KERR-McGEE CHEMICAL LLC

Subject: KMCLLC Response to Phase II Report Comments

**SUPPLEMENTAL PHASE II
WORK PLAN**

FIGURE 2-1

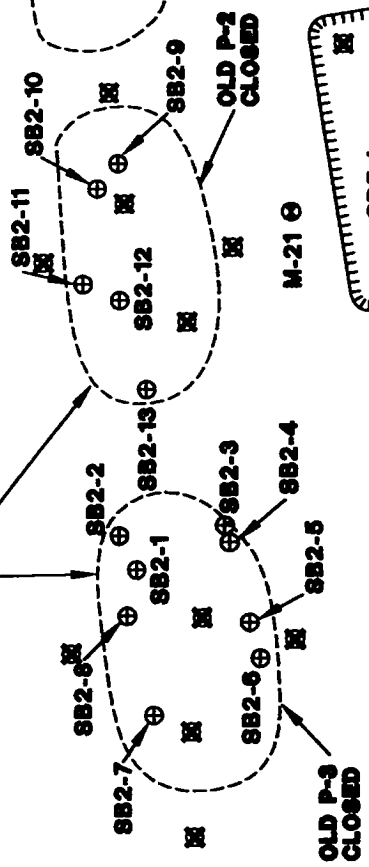
We agree that further work is required. More areal and subsurface definition is required. Please provide a workplan for the proposed work.

We agree that further work is required to determine the affected volume of soil. Please submit a workplan for this work.

We agree that groundwater from M-21 does not appear to be impacted by diesel; consequently no further monitoring well installation is required. However, TPH should be routinely sampled from M-21 in the future.

To define the areal extent of residual chromium resulting from the former use of the impoundments, eight borings will be advanced along the outer perimeter of the ponds (See Figure 2-1). The perimeter borings are proposed in locations that will enable the lateral and vertical limits of chromium in soil to be assessed. The perimeter borings are located just outside the berms encircling the chromium-containing soils within the Old P-2 and Old P-3 Ponds, Figure 2-1. The perimeter

Four additional borings will be advanced in a similar manner within the interior boundaries of the former ponds (see Figure 2-1). The interior borings are located near areas of earlier chromium detection and are intended to confirm the extent of vertical chromium migration in soil, and to assess whether chromium-containing soils extend to the depth of groundwater. Sampling will be conducted at two-foot intervals to the capillary fringe anticipated to be approximately 40 feet bgs. Samples will be analyzed for pH and total chromium until two successive samples are determined to be less than 100 mg/kg of total chromium.

Four additional borings will be advanced in the Diesel Fuel Storage Tank bermed area (see Figure 2-1). The four borings are located to surround previous borings which detected TPH-d, and to confirm the limits of diesel in soil. The borings will be advanced using a hollow-stem auger drill rig to the capillary fringe or an approximate depth of 40 feet bgs. Samples will be collected via a split-spoon sampler on five-foot intervals to the terminal depth at the capillary fringe.

At the request of NDEP to confirm no impacts to groundwater, a groundwater sample will be collected from M-21 (see Figure 2-1) during the upcoming field activities described above at the Old P-2 and Old P-3 Ponds and Diesel Fuel Storage Tank.
